**BRYAN J. DOLAN**  
VP, Nuclear Plant Development

**Subject:** Duke Energy Carolinas, LLC  
William States Lee III Nuclear Station – Docket Nos. 52-018 and 52-019  
AP1000 Combined License Application for the  
William States Lee III Nuclear Station Units 1 and 2  
Supplemental Response to Request for Additional Information (RAI No. 50)  
Ltr# WLG2010.03-02

**Lee Nuclear Station Supplemental Response to Request for Additional Information (RAI)**

**Figure 7-3. Areas of Traffic Congestion 1 Hour after the Advisory to Evacuate**

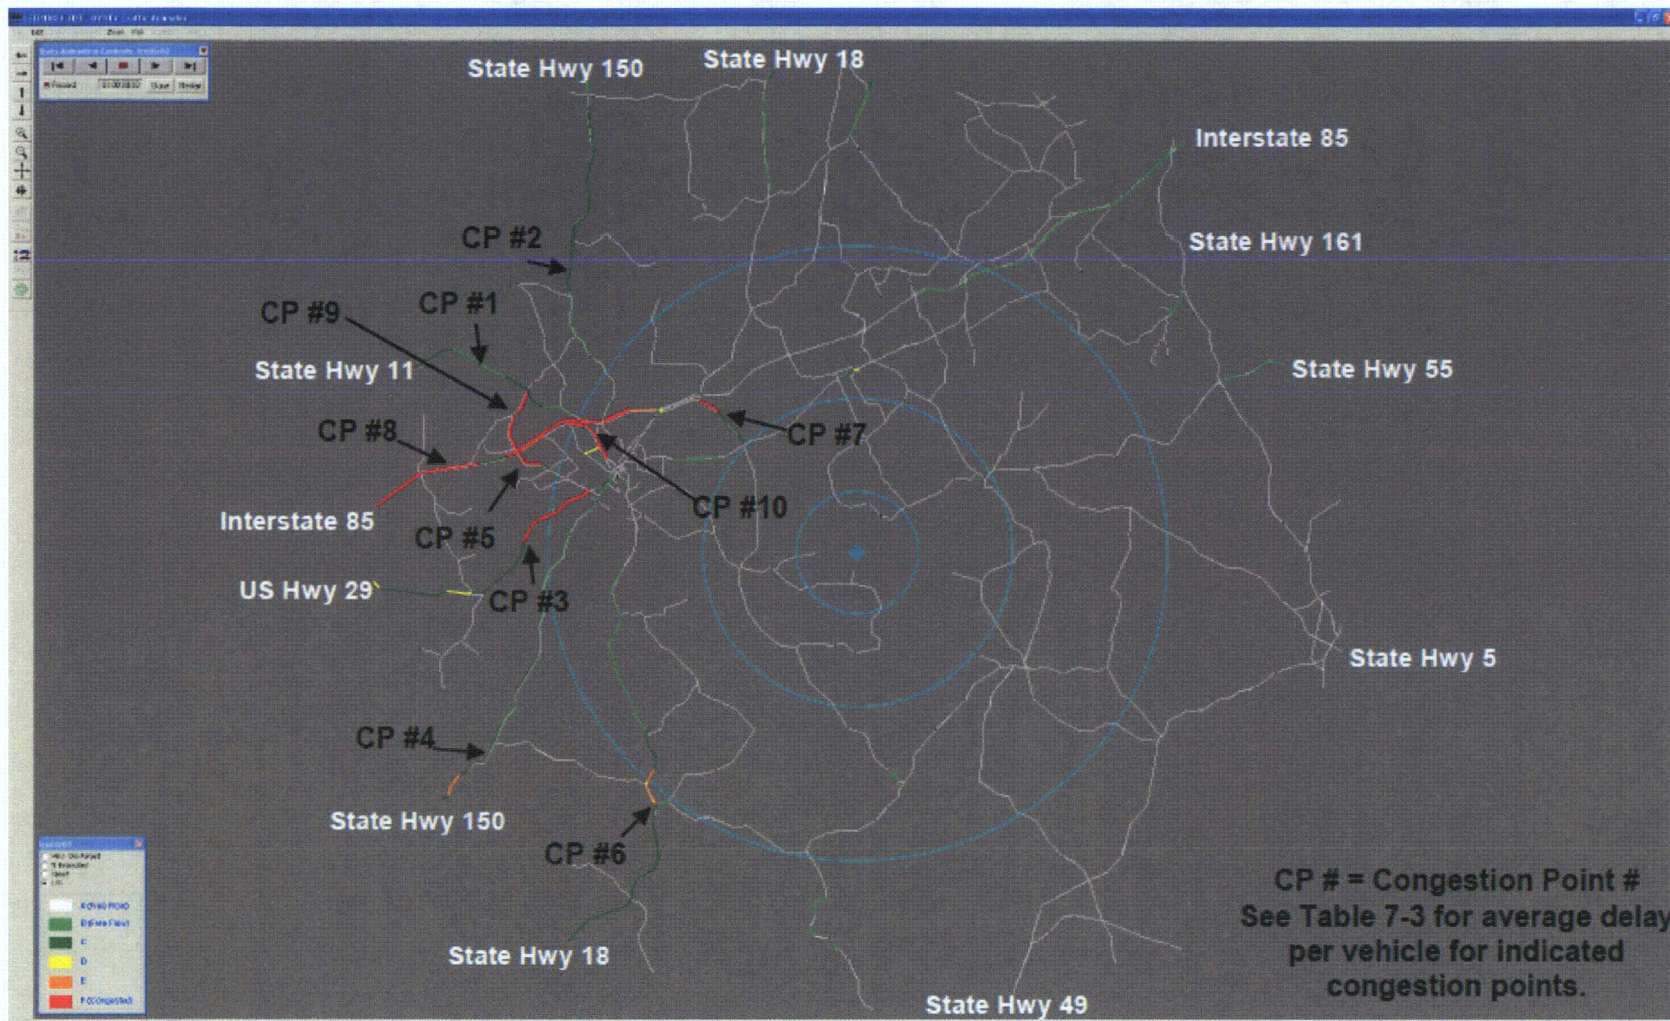
Patterns of traffic congestion are discussed in Section 7.2, "Patterns of Traffic Congestion During Evacuation." Congestion is expected to peak at 2 hours following evacuation and will begin to dissipate in most areas after the third hour. Figures 7-3 through 7-6, "Areas of Traffic Congestion 1-4 Hours After Advisory to Evacuate," illustrate the patterns of traffic congestion that arise for the case when the entire EPZ (Region R03) is advised to evacuate during the summer, weekend, midday period under good weather conditions (Scenario 3). The maps show congested areas in red and absence of congestion in white but delay times are not indicated. Provide additional information on delay times.

All highway "links" which experience LOS F are delineated in these Figures by a red line; all others are lightly indicated. Congestion develops rapidly around concentrations of population and traffic bottlenecks. ~~Many~~All of the major routes out of Gaffney are congested one hour (Figure 7-3) after the Advisory to Evacuate (ATE), including:
